RE: Pinnacle at Liberty Bay - P-06-20-25-03 -Individual Identity Plan Narrative and Elevations

PINNACLE AT LIBERTY BAY PRD

Pinnacle at Liberty Bay

Preliminary Architectural Elevations - July 15, 2025

PLAN 2

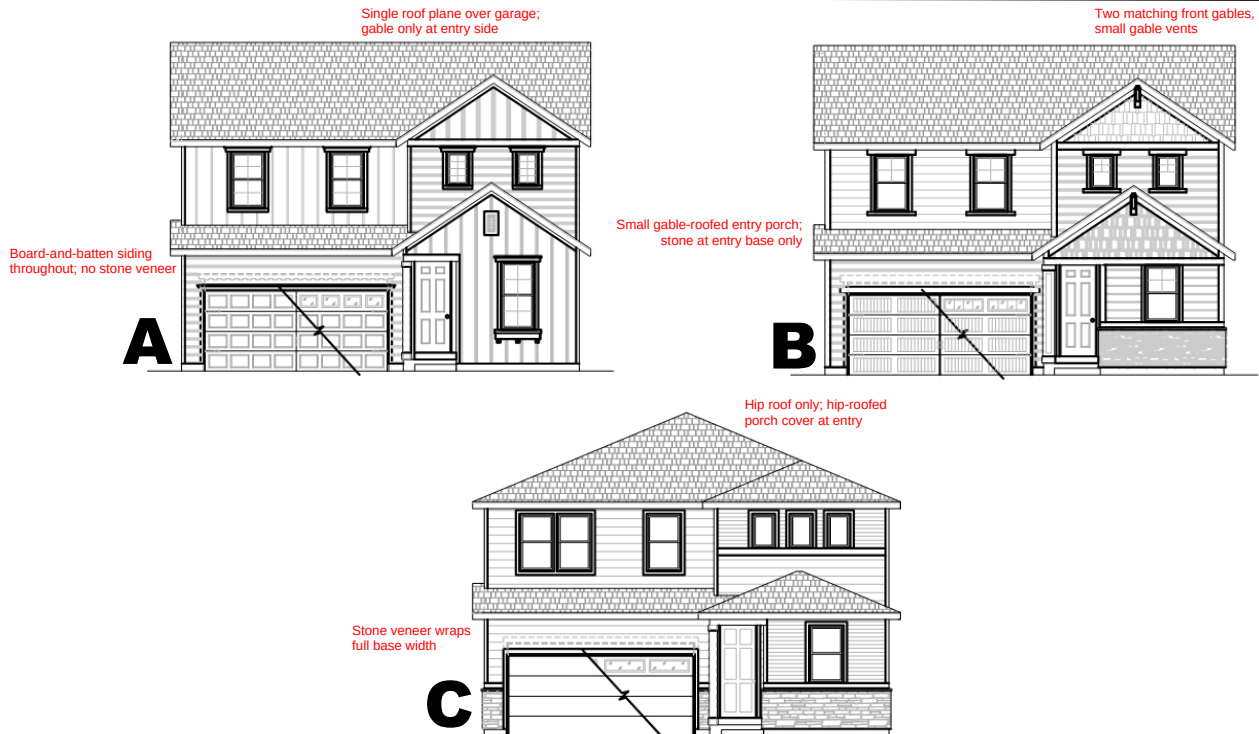
PMC 18.260.060(E) response letter: ROOF FORM/PITCH - "Roof configurations and silhouettes vary... including differing front-gable conditions, ridge arrangements, and massing between plans." GARAGE PLACEMENT - "Garage width and position...differ from plan to plan...a tuck-under condition inherently changes massing and garage prominence relative to a flat-lot condition."

PLAN 4

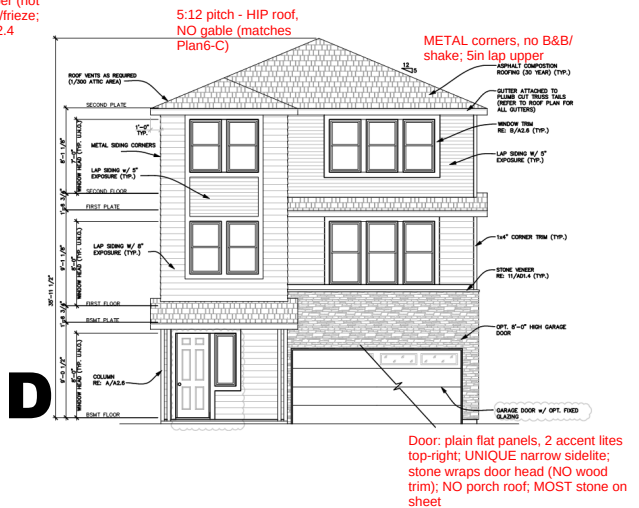
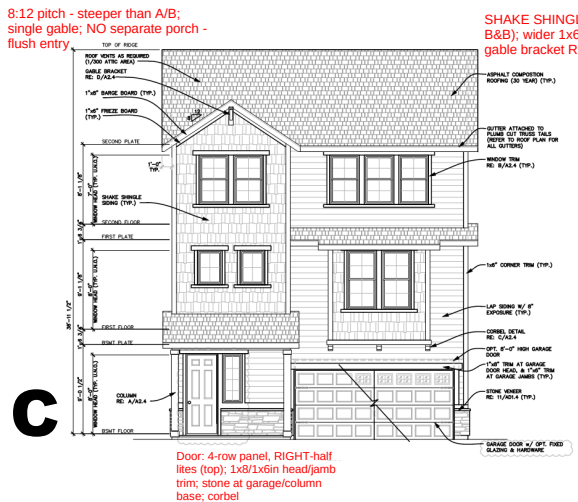
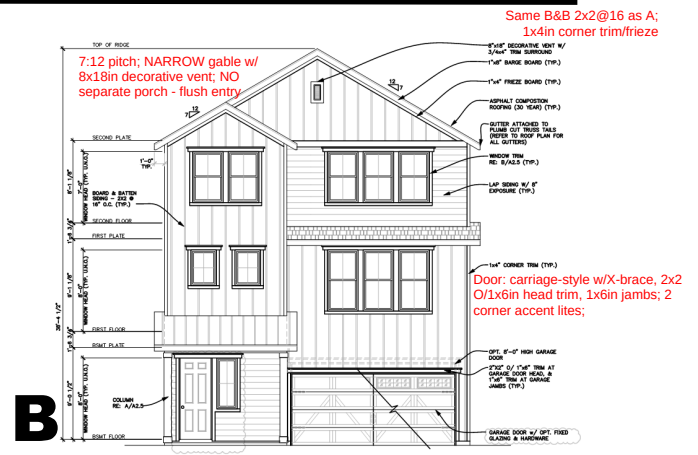
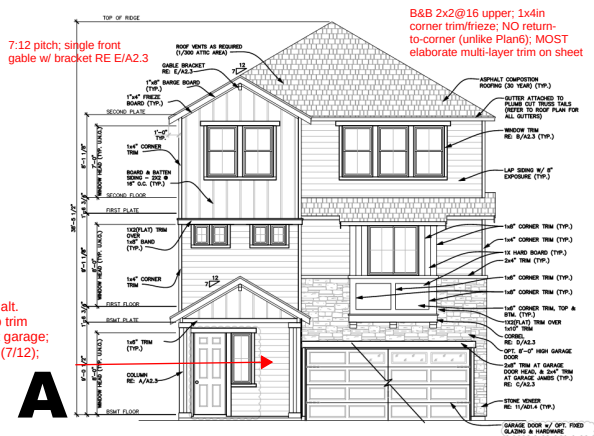
Front gable at garage; 2nd
gable at entry bump-out

Front gable, shake-shingle
texture (vs. board & batten)

3 transom windows above
garage door

Small gable entry canopy;
stone piers at garage only

Hip roof only - no front gable

Stone veneer wraps
entire entry wing

PLAN 5

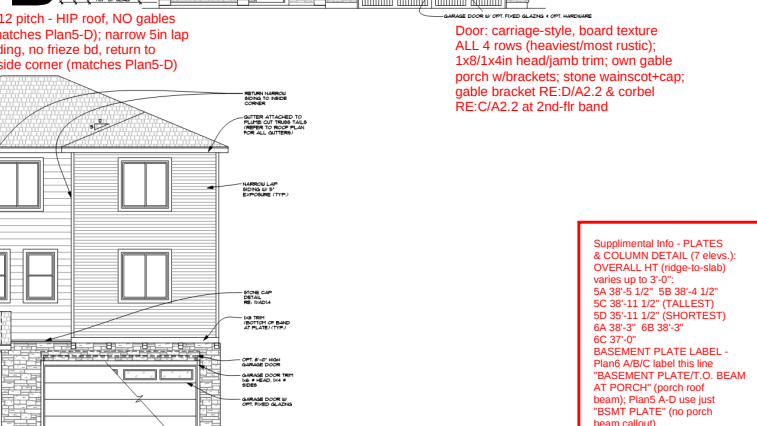
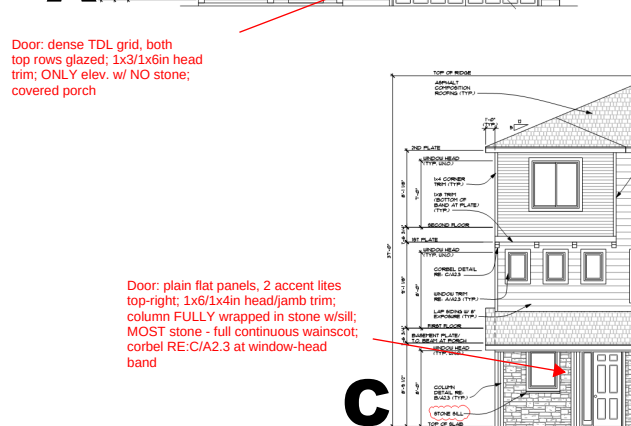
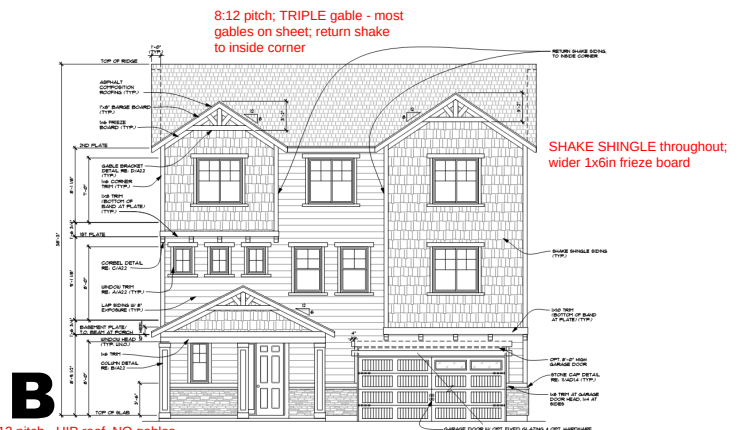
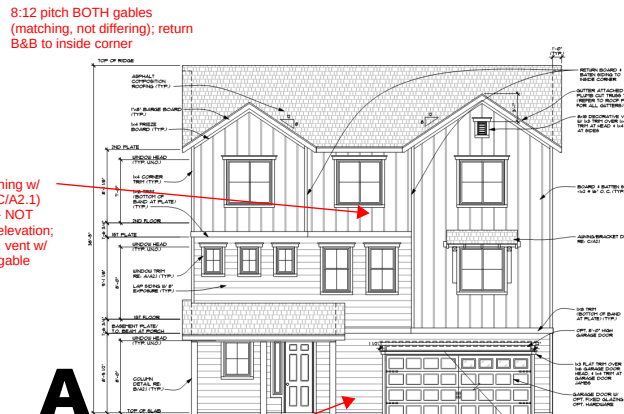
PMC 18.260.060(E) response letter: roof form, pitch, gable count & porch massing unique feature (6-A awning/bracket) garage DOOR STYLE, head/jamb trim spec, stone veneer extent & entry/column treatment SIDING/TRIM - "Page 4 identifies varying roof forms and porch massing, garage door panel styles, glazing patterns and trim dimensions, siding textures, corner trim widths/layering, and stone veneer coverage that vary plan to plan."
